May 30, 2008
Subject: **Norridgewock**
Project No. BH-6900(01) X
Pin No.006900.01
Amendment No. 8

Norridgewock Covered
 Bridge

Reference #2

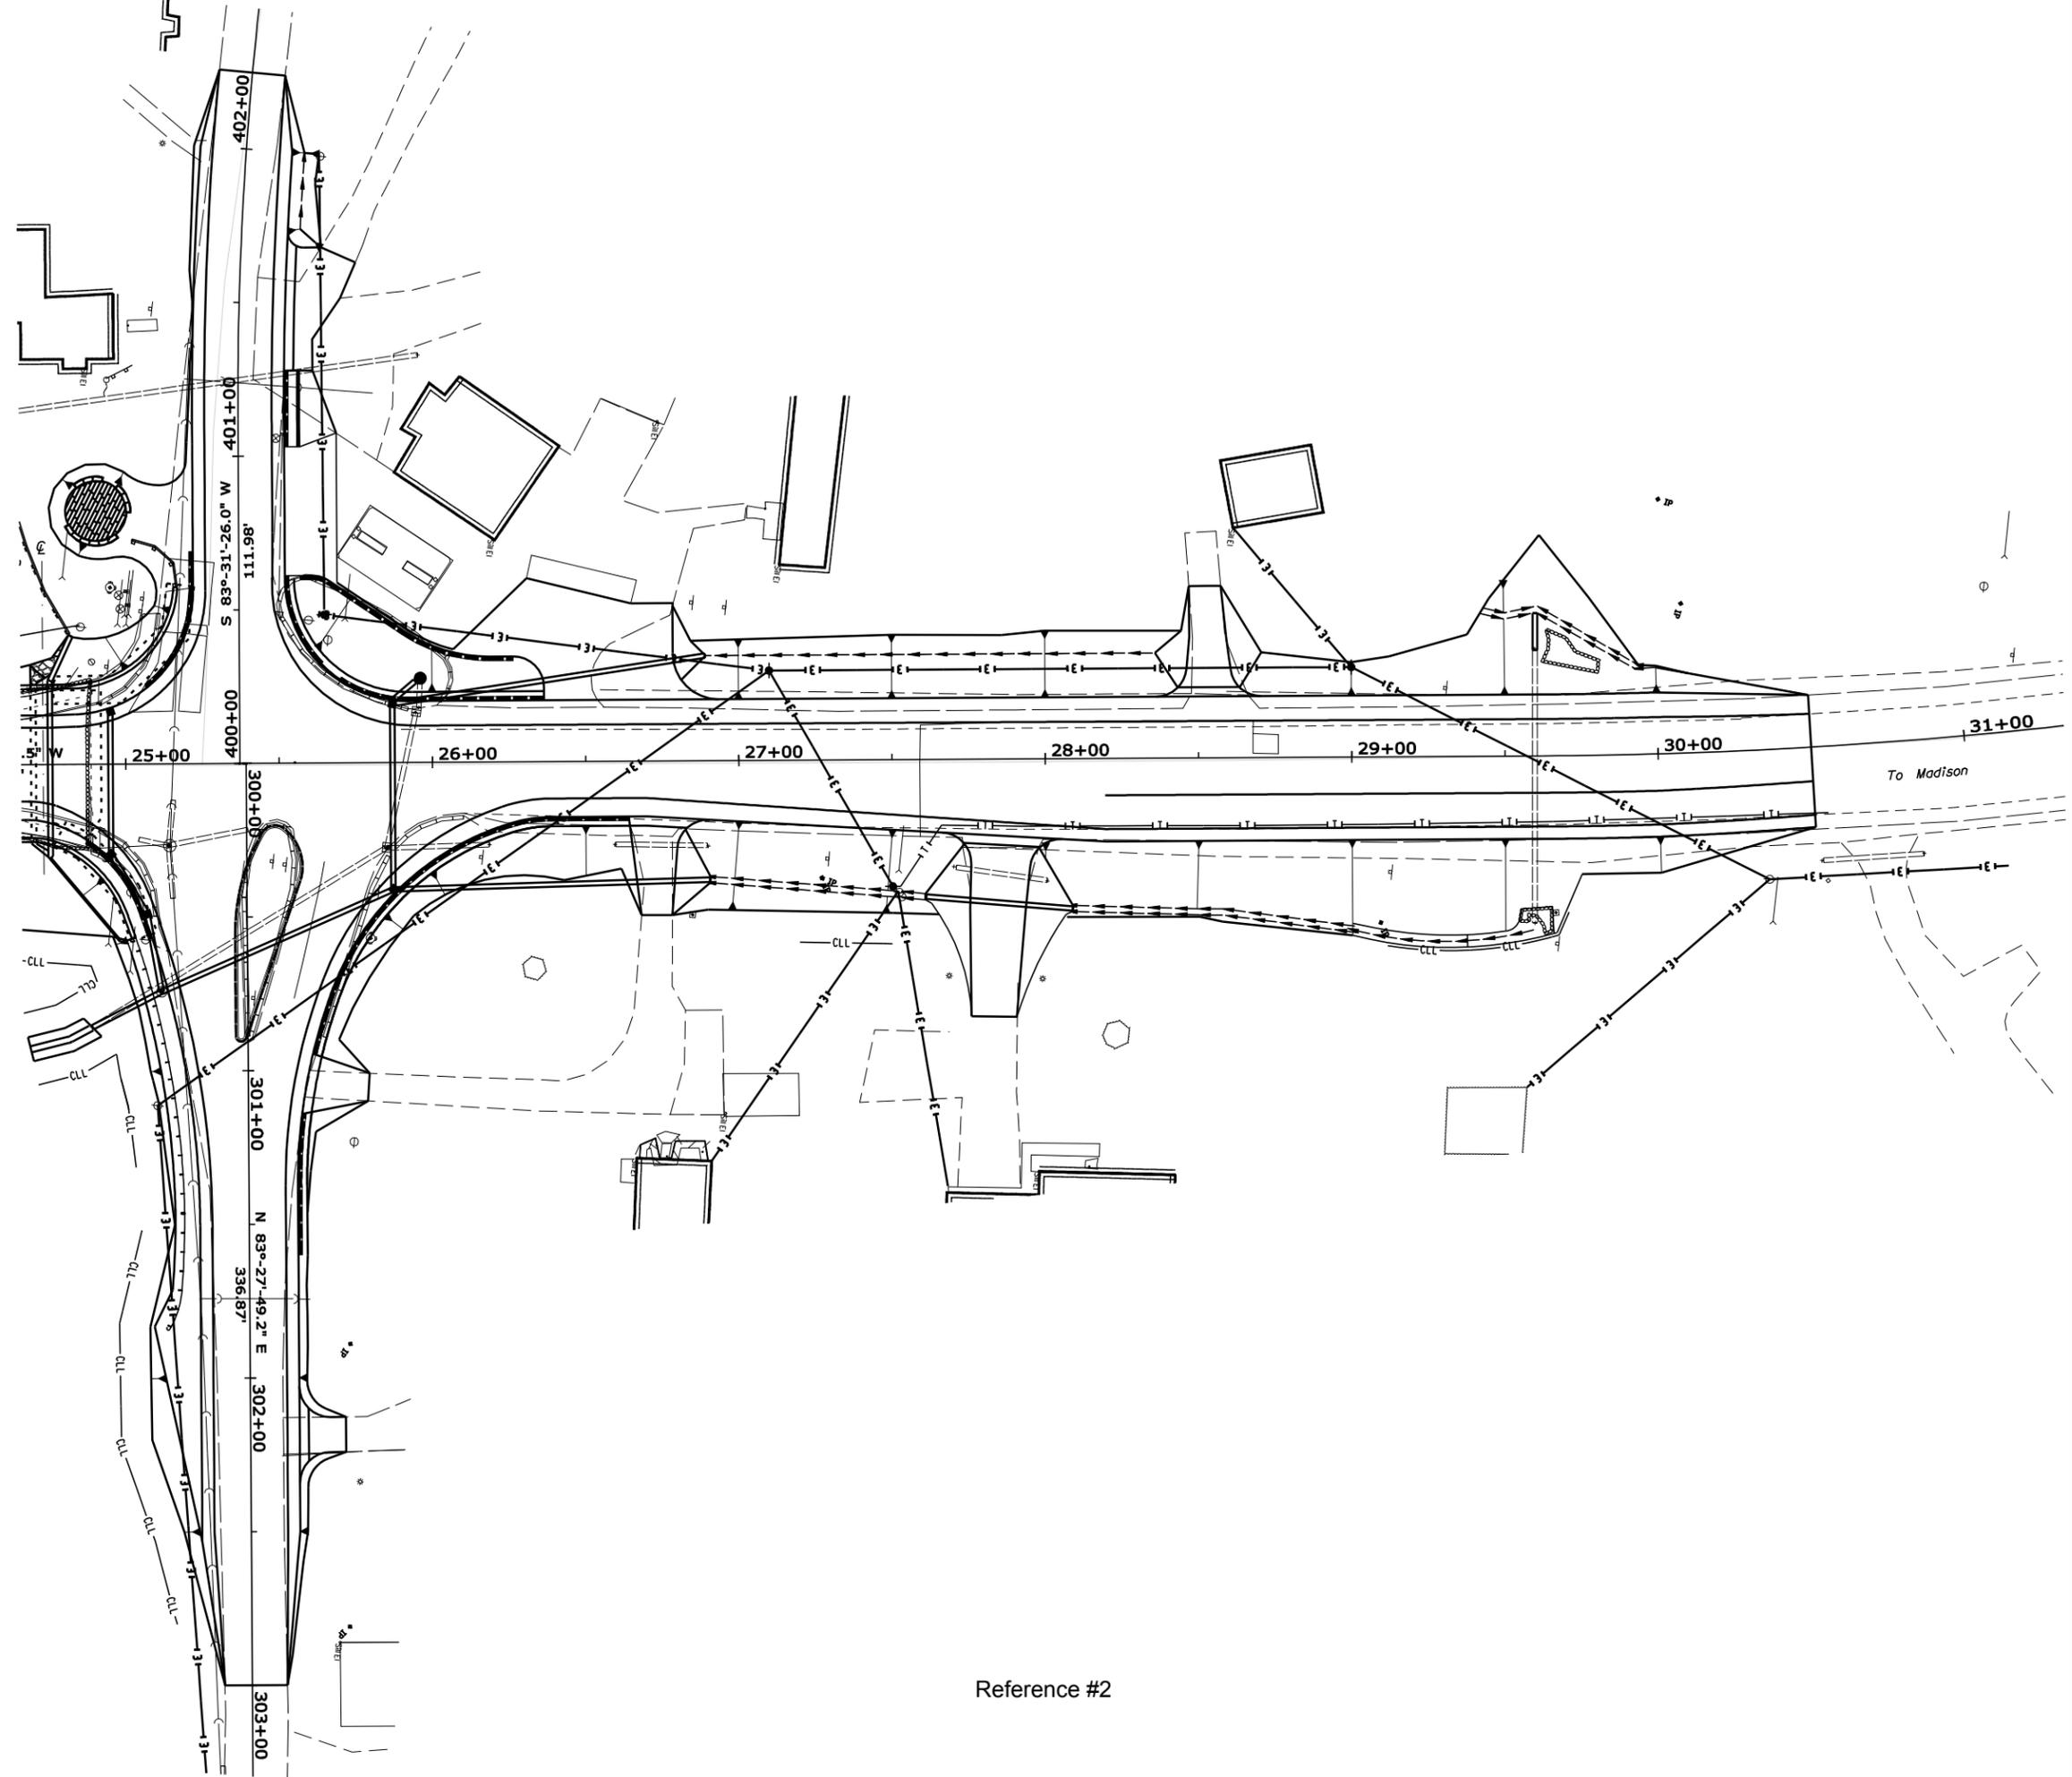
Question: Will the existing aerial utility lines that cross over Route 201A/Route 8, on both ends of the existing bridge be removed for construction?

Response: The aerial utilities will be relocated approximately 250' downriver which will clear the immediate ends of the existing bridge for construction. Please refer to the attached Utility Plan (**REFERENCE #2**) which shows the approximate locations of the aerial utilities.
